**TOWN OF MOUNTAIN VILLAGE  
REGULAR DESIGN REVIEW BOARD MEETING**

**TO:** Mountain Village Design Review Board  
**FROM:** John Miller, Senior Planner  
**FOR:** Design Review Board Public Hearing; August 6, 2020  
**DATE:** May 20, 2020, *Updated July 24, 2020*  
**RE:** Staff Memo – Final Architectural Review (FAR) Lot AR-2

**1 SITE LANDSCAPE PLAN**  
SCALE: 1/8" = 1'-0"

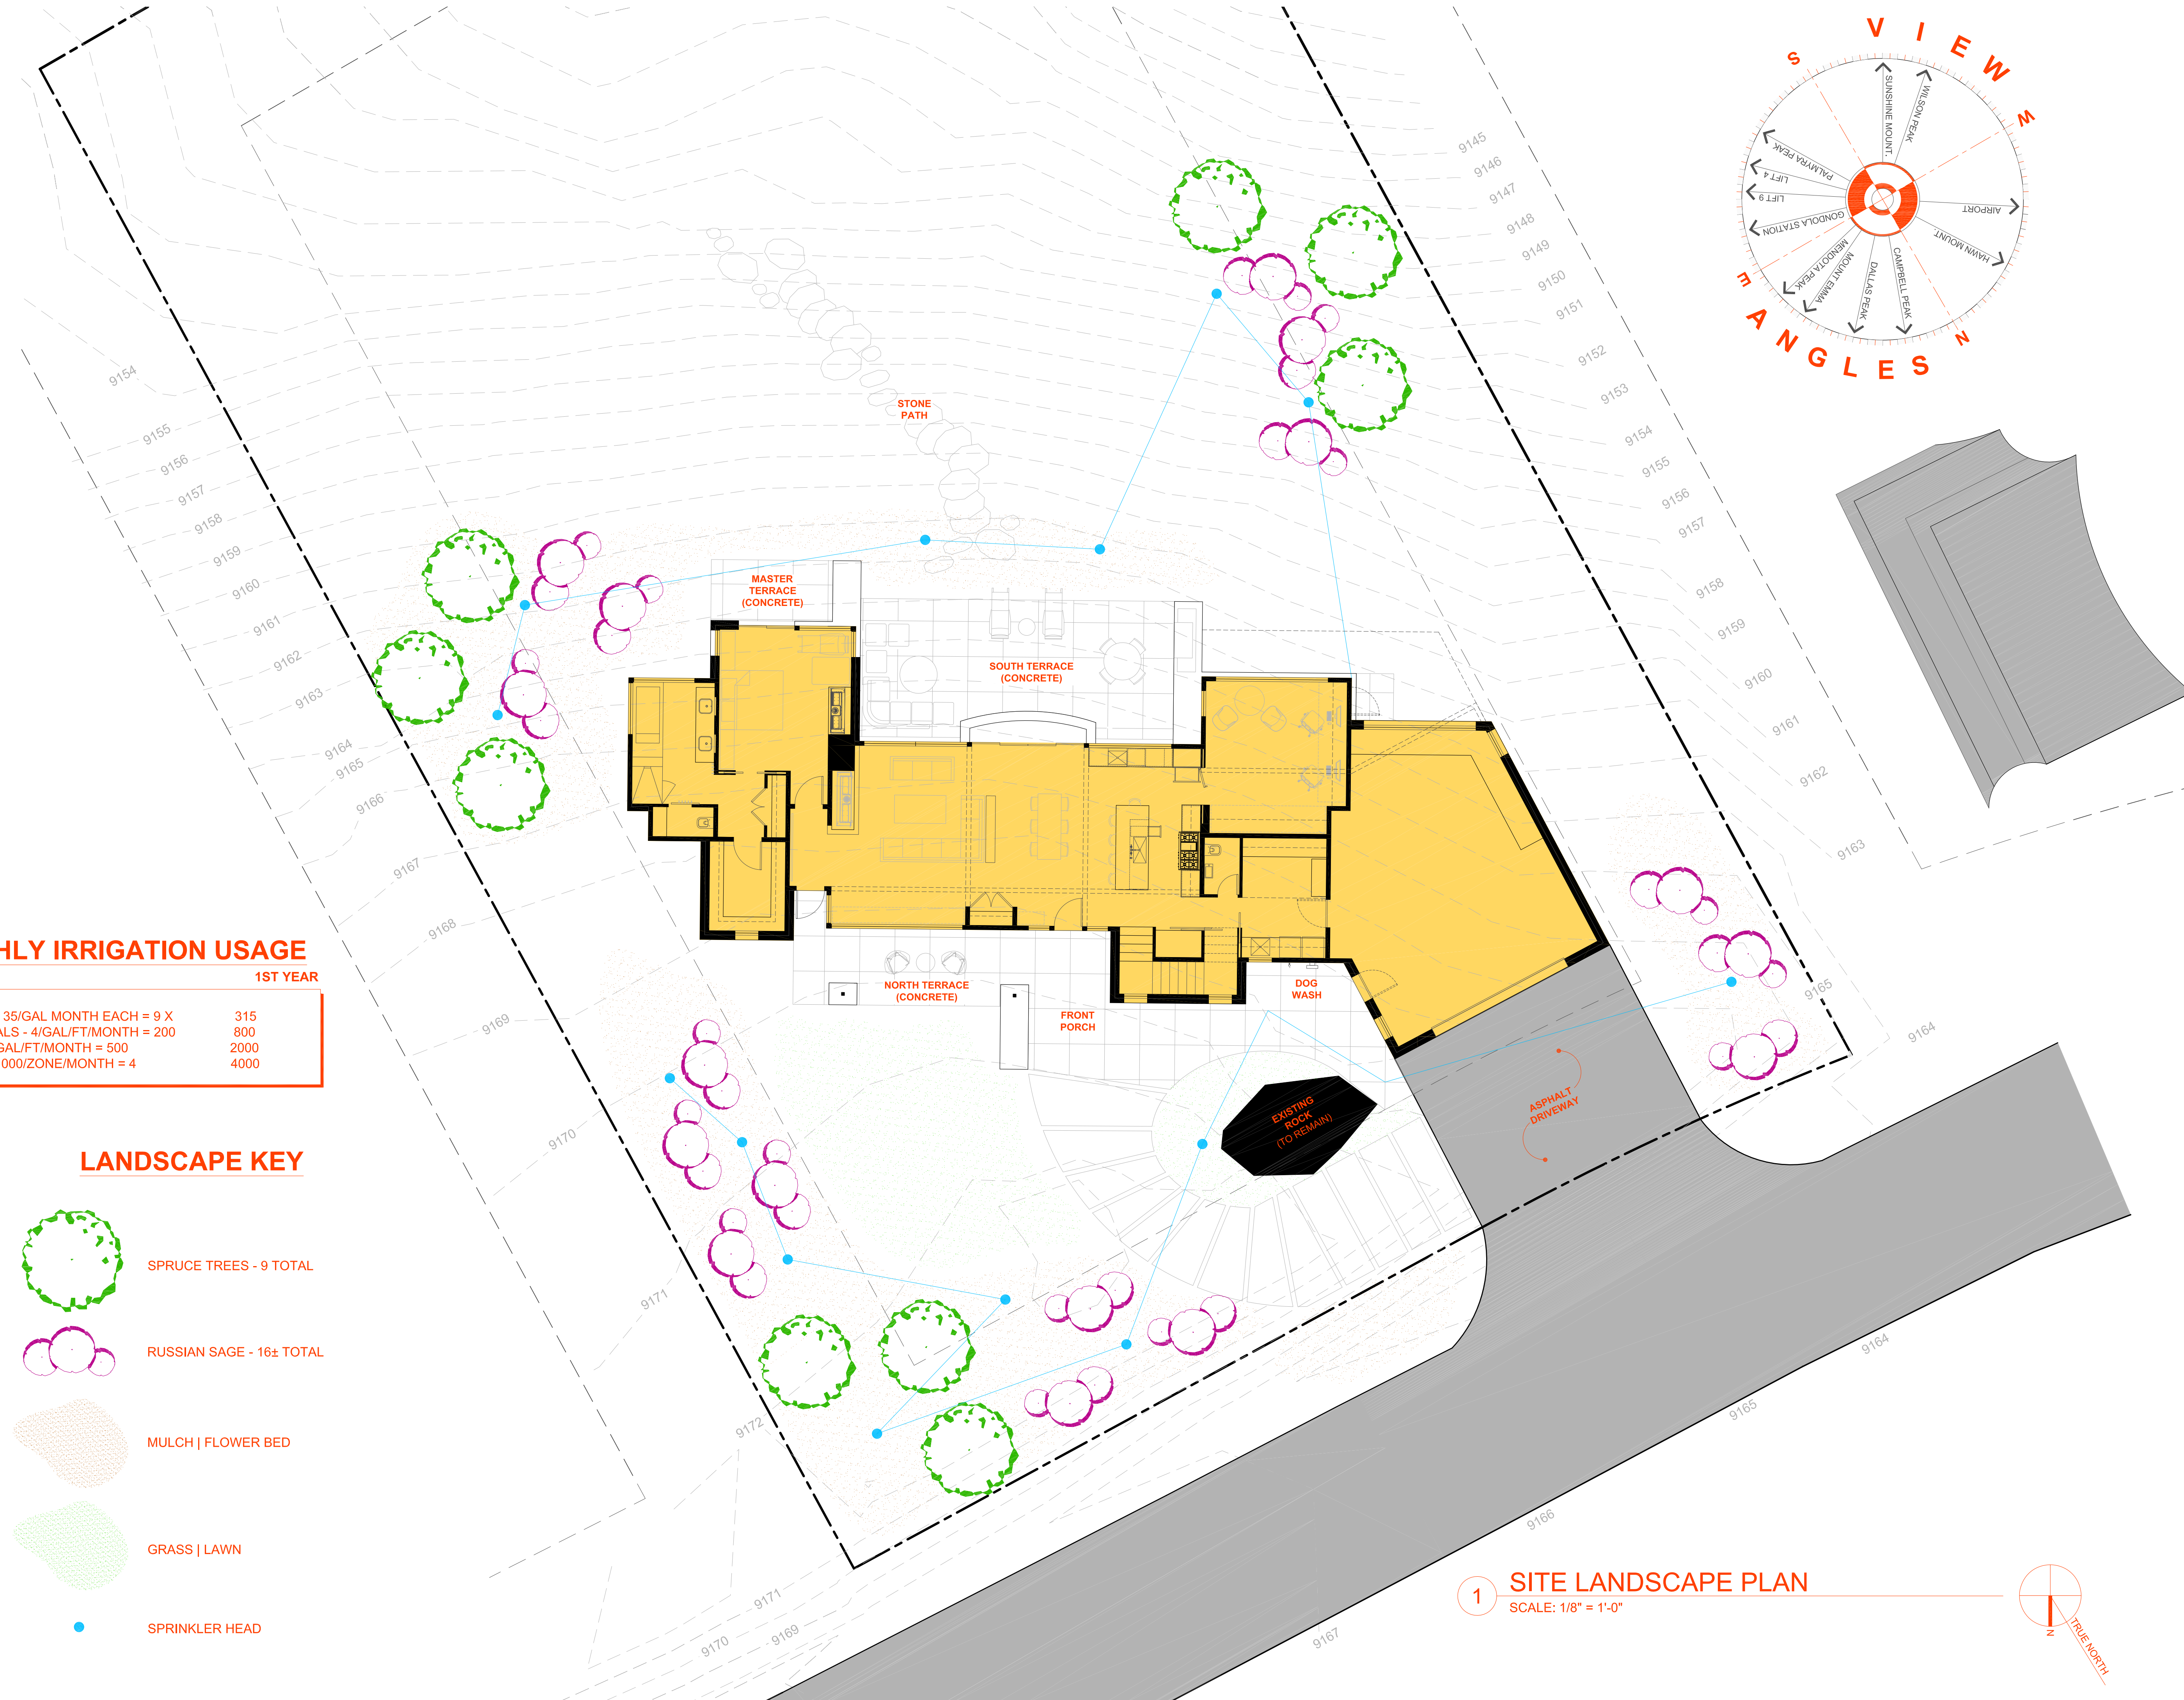
*The applicant has provided and updated landscaping plan for the final review. The plan appears to generally meet the requirements of the CDC, but additional details related to plant sizes, installation methods/maintenance, as well as other specific details should be provided as part of a construction plan set for building permitting. If the DRB determines it to be appropriate, staff believes this can be handled as a condition of approval.*

*There is one area that staff is requesting a full modification of the landscaping plan: The applicant is proposing mulch to be located within the Town Right of Way. Staff is recommending that this proposed landscaping area be removed in its entirety from the proposal. The applicant may re-veg this area, but staff does not recommend planting or mulching.*

- a. Maximum Height – 34.0'
  - b. Average Height – 20.17'
3. Exterior parking is entirely on Lot AR2
4. The landscape plan has been evolved to show the location, quantity and species of plants as well as the location of the sprinkler heads.

**1 CONSTRUCTION MITIGATION PLAN**  
SCALE: 1/8" = 1'-0"

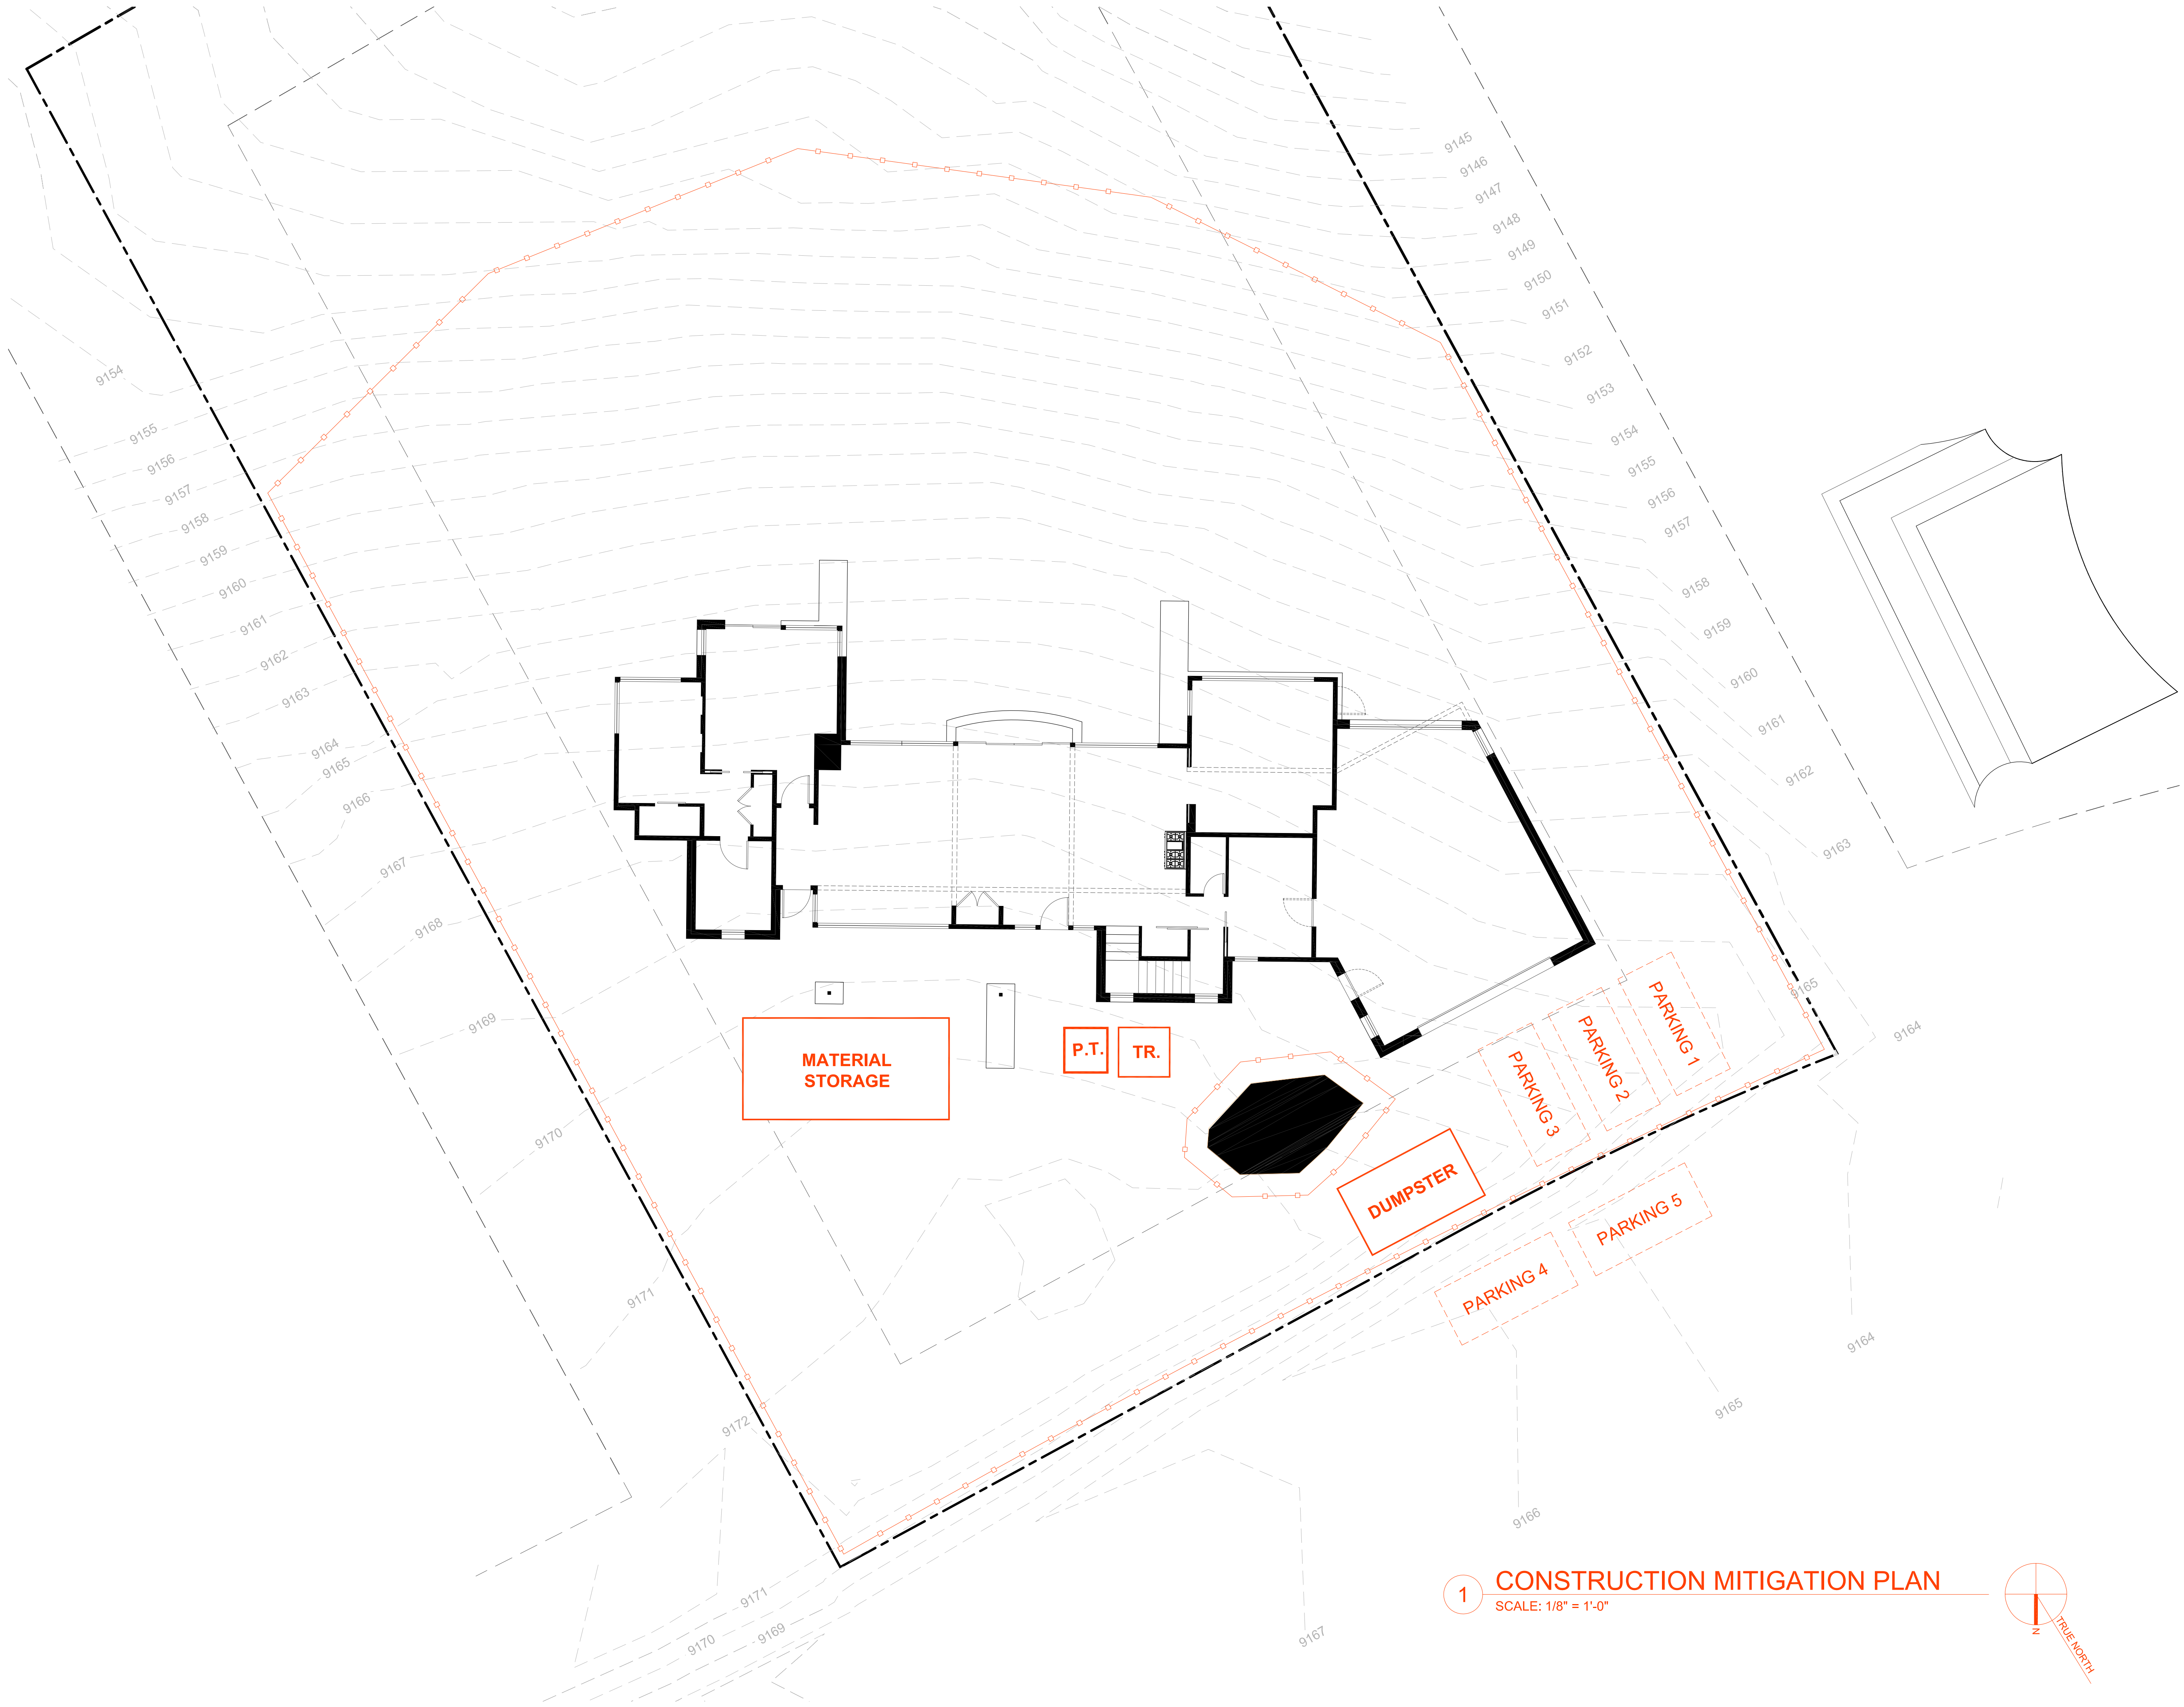
*Staff: The applicant has submitted a CMP as part of this application. Staff supports the proposal but also notes that a large portion of the staging area is located in areas that will be ultimately landscaped and over time, the project may lose some of the parking as shown on the plans. There is very limited on-street parking in this location and the contractor should work to determine how to stage as areas identified as parking and storage start to be eliminated over time.*
